05V-112

VEHICLE RECALL

SC294

Subject: Interference Condition Between Adjustable-Length Torque Rod and Left-Side Brake Chamber — CXN and CHN Model Chassis Equipped with Air Suspension and MACK Rear Axles

Figure 3 — Adjustable-Length and Fixed-Length Torque Rods

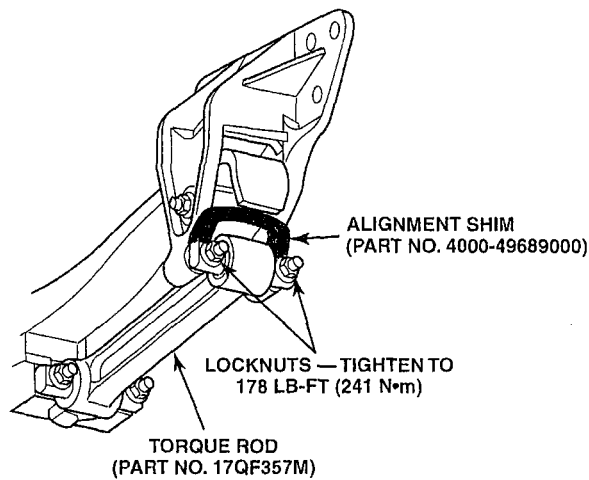
If equipped with adjustable-length torque rods, they must be replaced with fixed-length torque rods (part No. 17QF357M).

17QF466M ADJUSTABLE-LENGTH TORQUE ROD

17QF357M FIXED-LENGTH TORQUE ROD

Figure 4 — Longitudinal Torque Rod Mounting

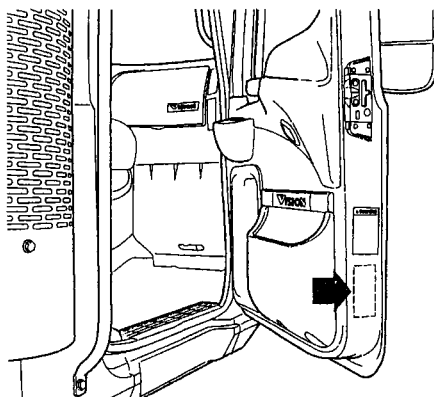
Proper thrust angle is obtained by installing alignment shims (part No. 4000-49689000) between the torque rod bar pin and the front frame hanger bracket on both the left- and right-hand sides of the chassis as required. Once proper alignment has been obtained, tighten the torque rod fasteners to 178 lb-ft (241 N•m).
